HEARING DATE: February 16, 2023

SUBJECT: Millwood Subdivision
H-2022-0089

LOCATION: 1975 E. Victory Rd., in the NW 1/4 of Section 29, T.3N., R.1E. (Parcel #S1129223095)

C. Landscape Plan (dated: 12/1/2022)

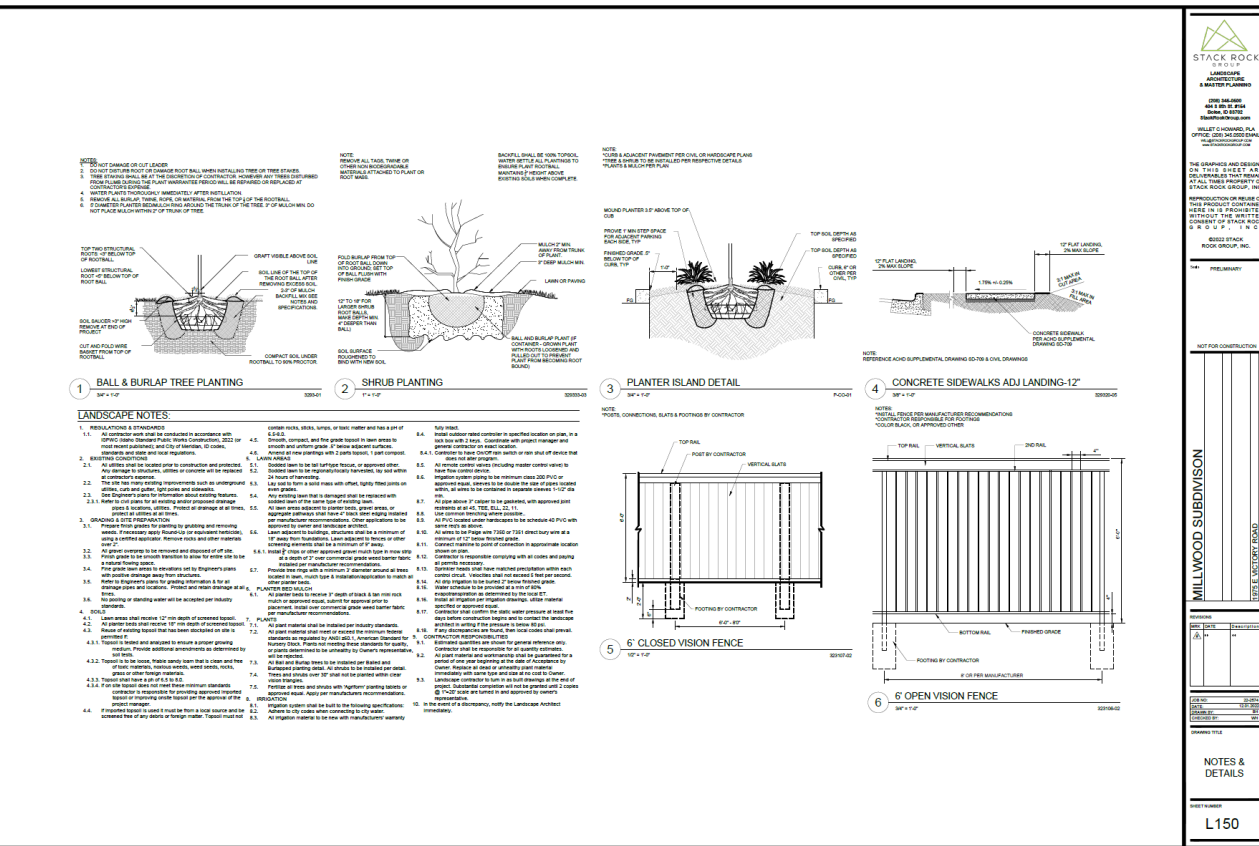
Landscaping is required along all pathways per the standards listed in UDC [11-3B-12C](#); **the landscape plan should be revised to include landscaping along the micro-path in the common lot at the southwest corner of the site and along the multi-use pathway along the northern portion of the east boundary of the site. Calculations should be included demonstrating compliance with these standards.**

There are a lot of existing trees on this site, many of which are proposed to be preserved and protected as depicted on the landscape plan. **Mitigation is required for trees being removed from the site per the standards listed in UDC [11-3B-10C.5](#) and should be depicted on the landscape plan.**

The landscape plan incorrectly depicts an irrigation easement over the common lot at the east boundary of the site; the plan should be revised to remove the easement.

3. The landscape plan submitted with the final plat shall include the following revisions:
 - a. Revise the lot configuration as required in conditions #2a and #2f above.

- b. Depict landscaping if desired in the right-of-way required to be dedicated for the future extension of Richardson St. from Tamayo Ct. to the east property line. A license agreement will be required with ACHD for landscaping within this area per the ACHD staff report (condition #2).

- c. Depict a 10-foot wide multi-use pathway with a 5-foot wide strip on each side of the pathway in the common lot along the northern portion of the east boundary of the site (north of the existing bridge across the Eight Mile Lateral adjacent to Lots 1-3, Block 1 and Lot 3, Block 2), in accord with the “working” version of the Pathways Master Plan, landscaped per the standards listed in UDC [11-3B-12C](#).

- d. Include mitigation calculations on the plan for existing trees that are proposed to be removed in accord with the standards listed in UDC [11-3B-10C.5](#).

- e. Include calculations that demonstrate compliance with the common open space standards listed in UDC [11-3G-5B.3](#) and the pathway standards listed in UDC [11-3B-12C](#).

- f. Include a detail for each of the proposed fencing types and for the children's play equipment proposed for the tot lot.
 - g. Remove the perimeter fencing along the west boundary of the common lot at the southwest corner of the development where it adjoins common area in Teakwood Subdivision *if* the Applicant is able to coordinate with the adjacent developer to arrange no fencing on that development in the same area.

- h. Depict bollards across the emergency access driveway 30 feet from the right-of-way of Victory Rd. to prohibit public access; bollards shall meet the Fire Dept. requirements as either knock over or two bollards with a heavy chain and Knox padlock.

- i. Remove the irrigation easement depicted over the common lot along the east boundary of the site as there is no easement over that area.
4. The Applicant should coordinate with the adjacent developer of Teakwood Subdivision to the west to provide a break in the fencing where the common areas adjoin to allow the connectivity between developments and a larger overall open space area to be enjoyed by residents of both developments.
